APPENDIX 1.0

OFFICE CHANGES

277A GRAY'S INN ROAD

ADDITIONAL INFO - OFFICE CHANGES

Extract of basement plan as developed for construction with consented GIA overlaid

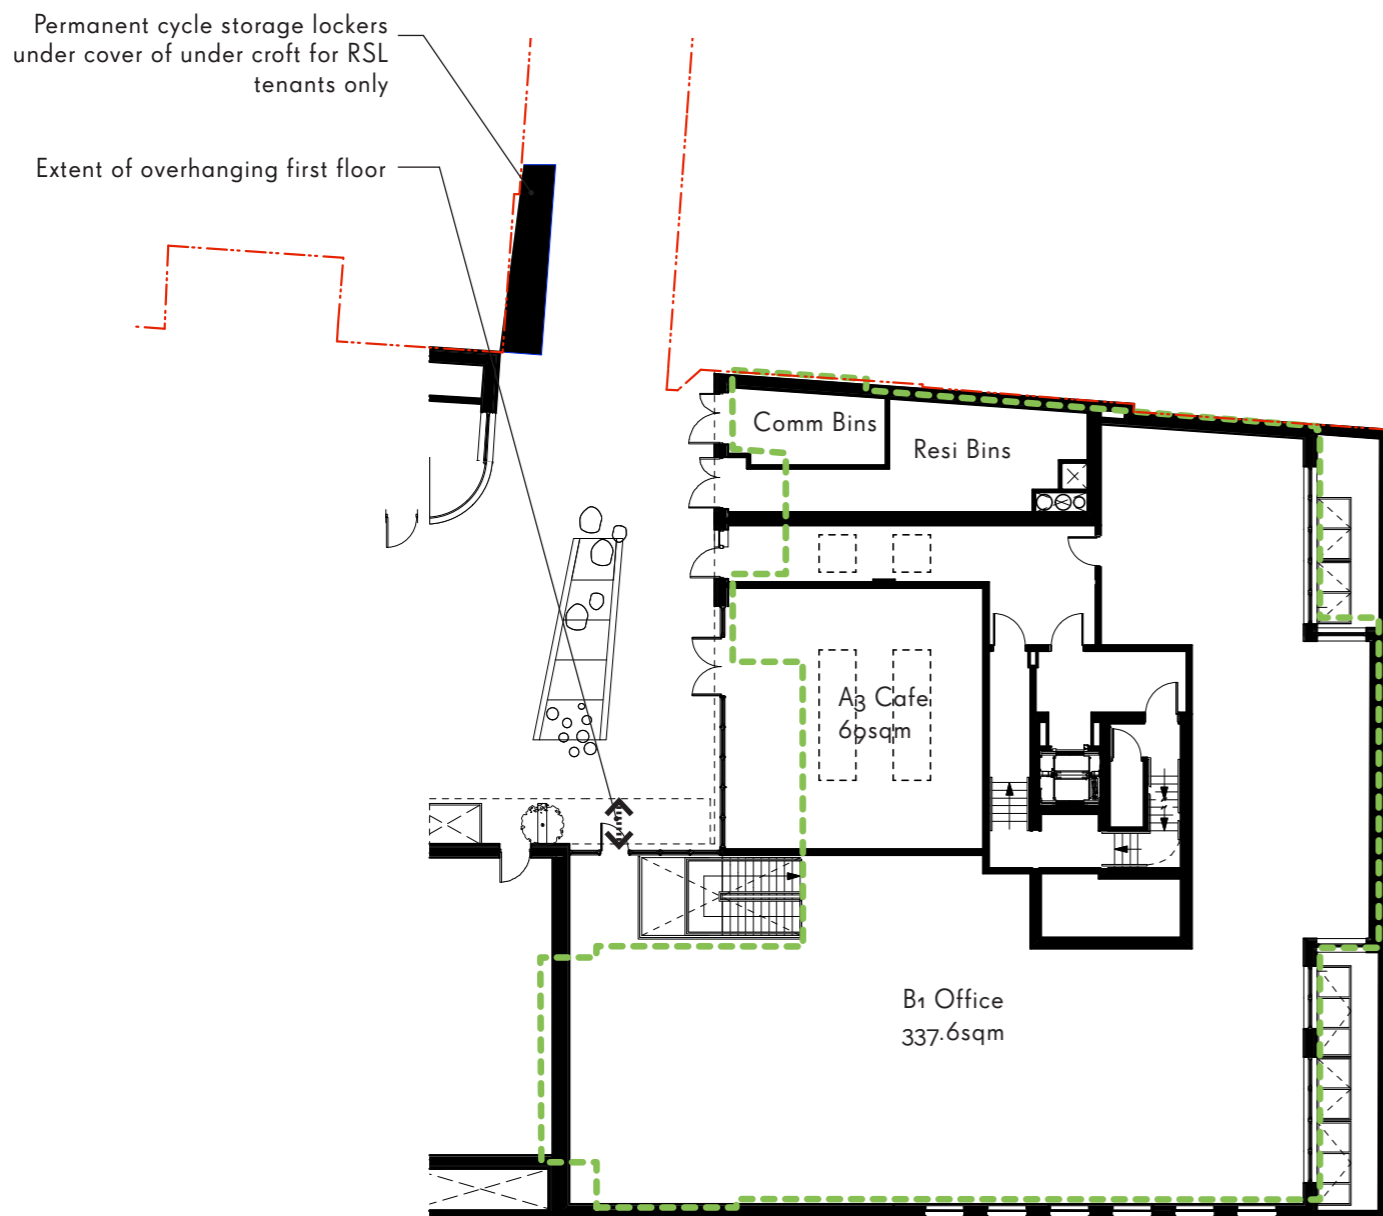
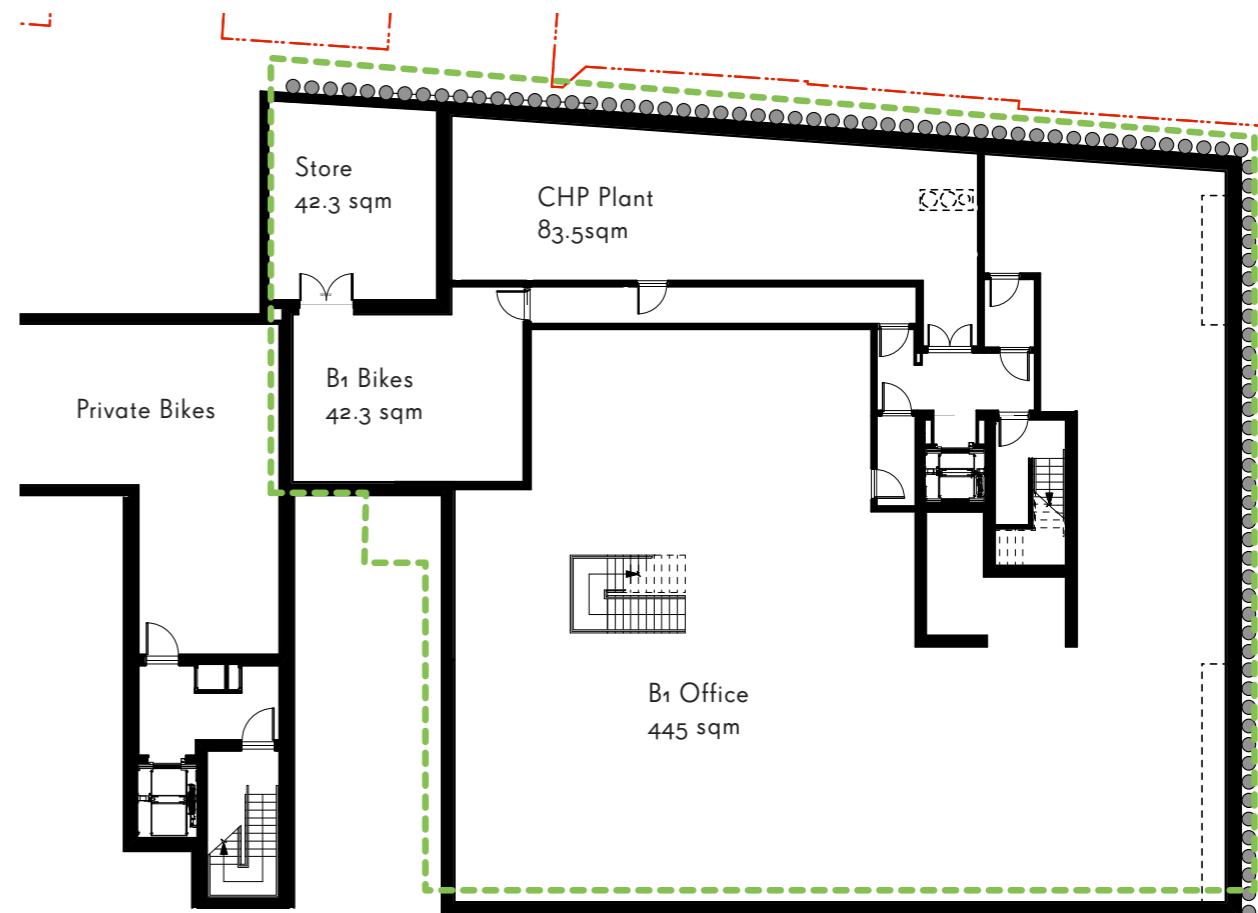
When overlaying the dotted green line onto the current plans, we can see that there are several areas, particularly at the boundary in the basement, where the gross internal area is significantly reduced from that shown at planning due to the need to provide concrete piles to retain the neighbouring buildings. In order to account for this, the ground floor has been reconfigured and areas of the overhanging entrance have been taken up to recoup floorspace. This also includes enlarged plant and maintenance store space. To help recoup employment generating space the SUDS tank has been omitted (see later section), the office lobby has been removed and RSL bike store has been moved.

B1 Office:	782.6 sqm
	-7.4
A3 Cafe:	69 sqm
	+2.4
Office Lobby:	0 sqm
	-28.8

SUDS:	0 sqm*
	-61.4
B1 Bikes:	42.3 sqm
	+9.3
RSL Bikes:	0 sqm**
	-25

CHP Plant:	53.1 sqm
	+30.4
Maintenance Store:	53.1 sqm
	+53.1

* SUDS tank omitted

** RSL bikes moved outside to undercroft lockers

Extract of proposed ground floor plan with areas of loss and recoup highlighted

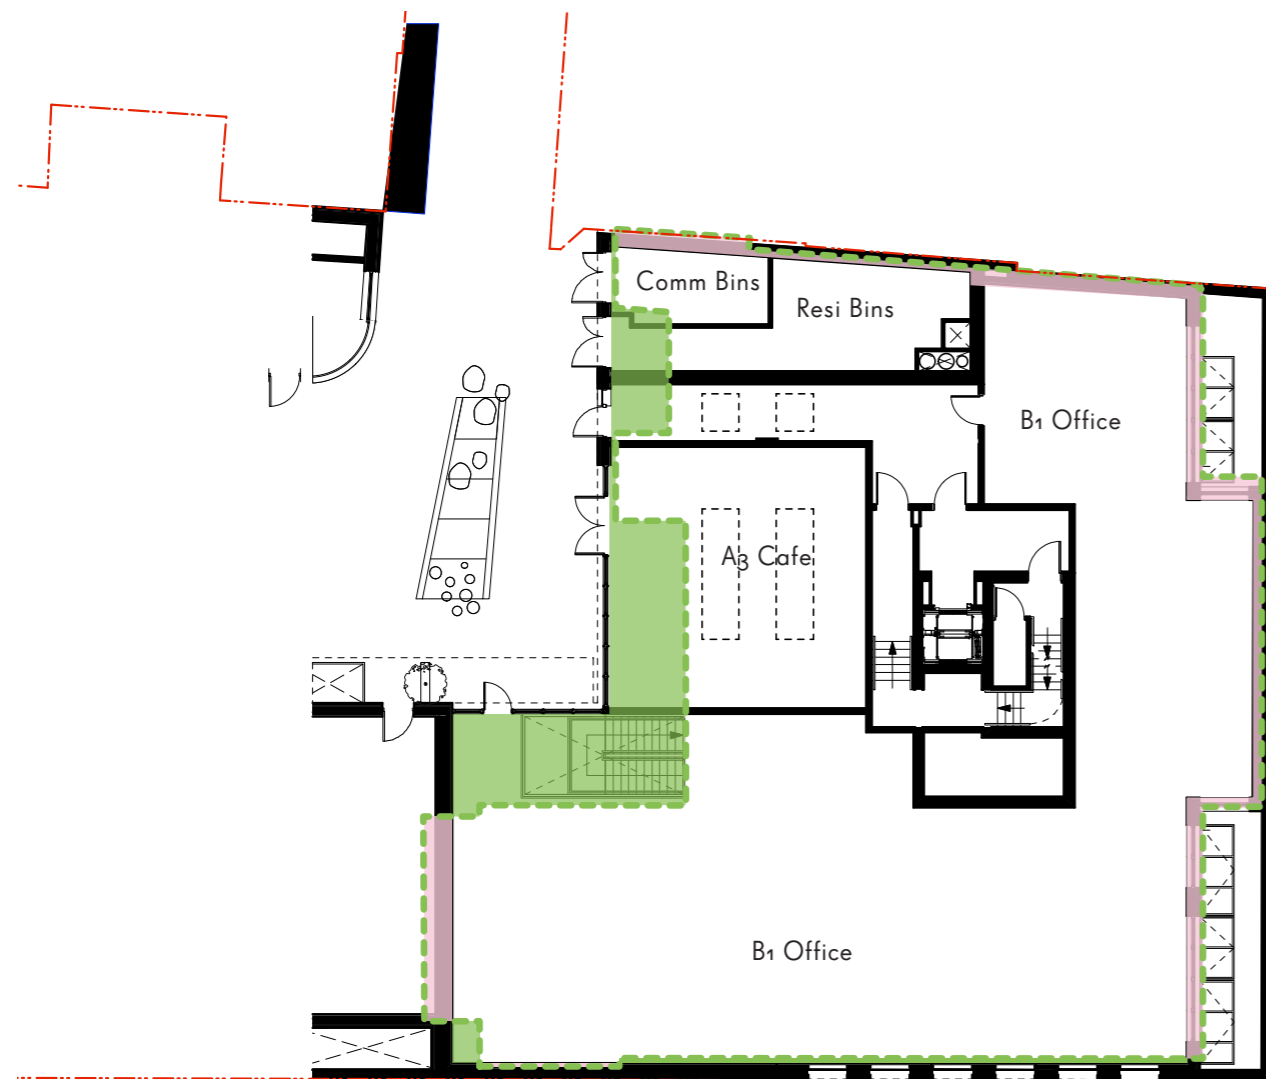
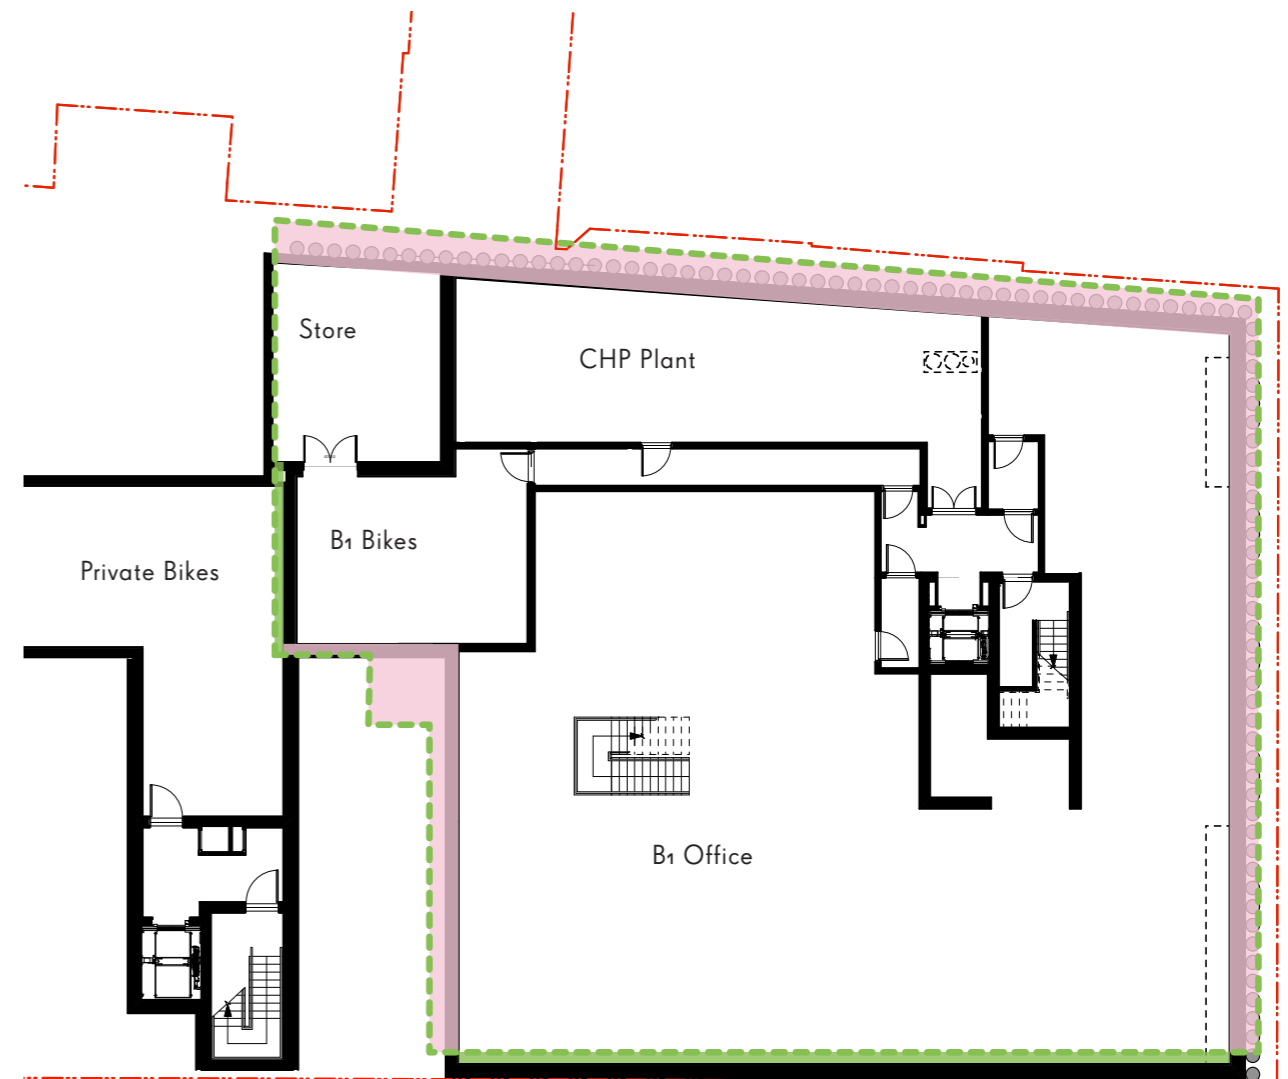
The diagrams below show more clearly where area has been lost from the planning consent and also, where it has been reclaimed. The total area lost (pink) is 112sqm and the total area regained (green) is 60.1sqm, showing a net loss of 51.9sqm

- Gross internal area of basement functions in this core
- 112
sqm
 Gross internal area lost since planning
- 60.1
sqm
 Gross internal area recouped since planning

Extract of proposed ground floor plan with areas of B1 and A3 Highlighted

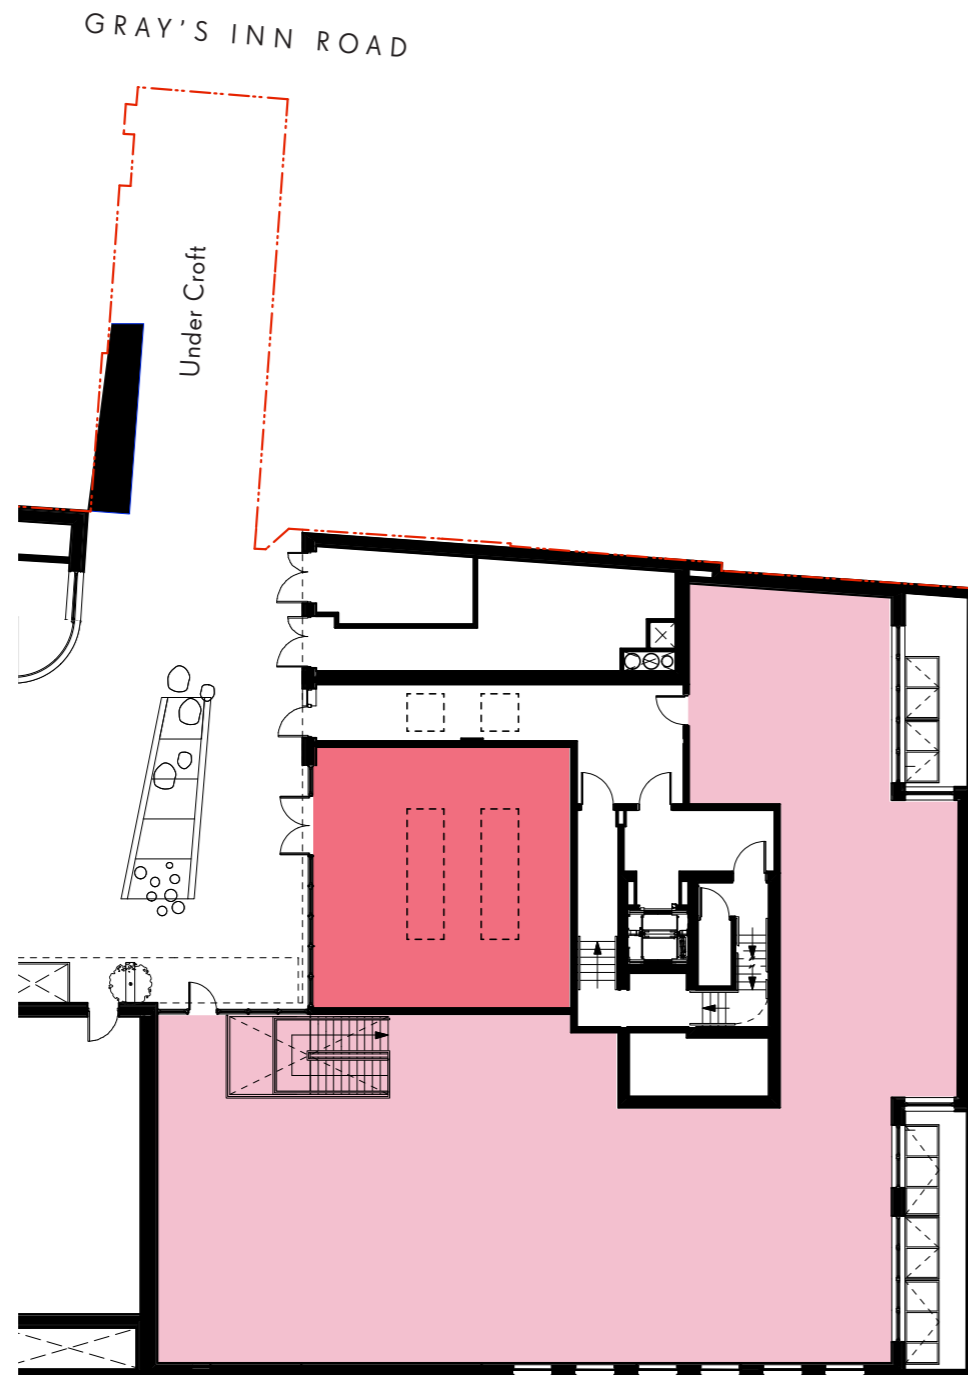
- Extant B1 consent to be maintained
- A3 consent proposed to be amended to A3/B1 flexible

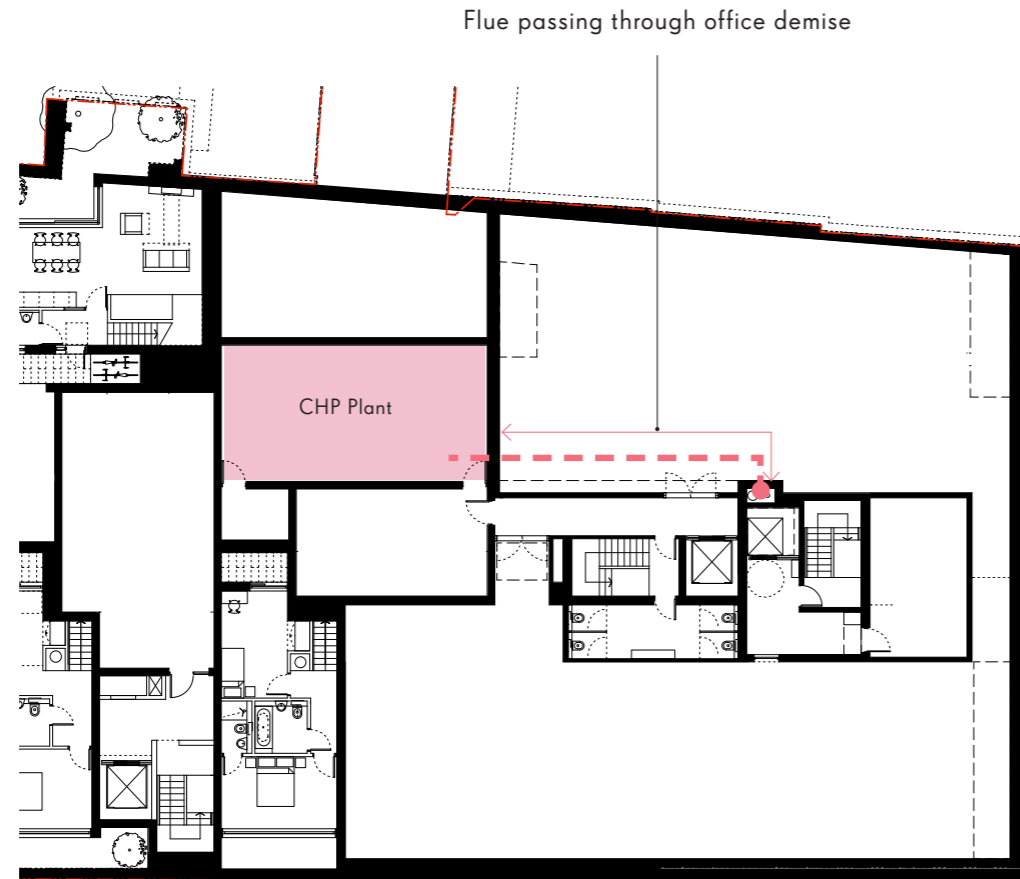
In developing the detailed design of the building, we found that additional space was required for structural support in a number of areas. In order to deliver a build-able design for the Basement and Ground Floor Commercial spaces, an area loss occurred, as detailed in the previous sections of this document. As a consequence of this, there remains a shortfall of let-table B1 space compared to that originally consented.

To safeguard the potential for an active frontage and to avoid any potential for long term vacancy, the client now seeks a flexible use class to the area previously identified for A3, allowing B1 or A3 in this area.

Proposed revised location of plant and flue route.

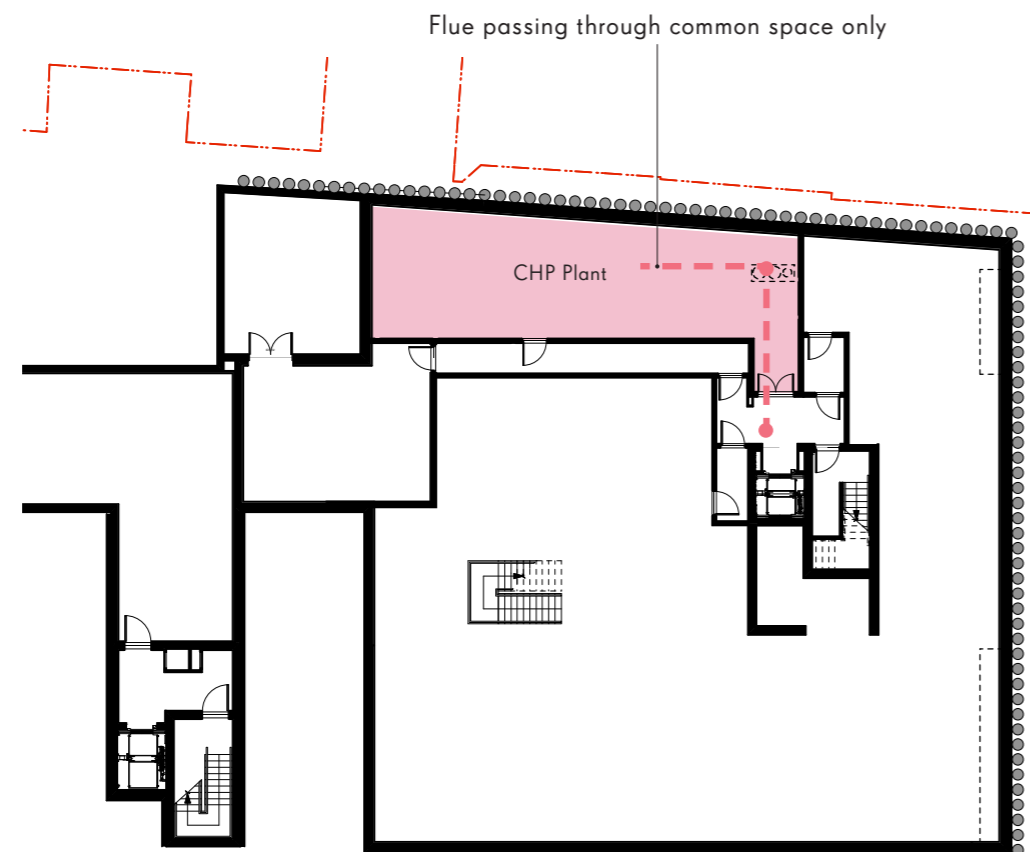
However, in the consented scheme, the boiler flue required several bends. Also, because the plant room was located remotely from the tallest vertical core, the flue needed to travel across the ceiling of the office accommodation in order to reach a riser to the roof. This is not an acceptable approach.

For that reason, the plant room has been moved closer to the tallest core in a part of the scheme that was previously designated as office space.

The size of the plant room has also needed to be increased by just over 30sqm (see earlier comparisons) to accommodate the necessary plant further to detailed design.
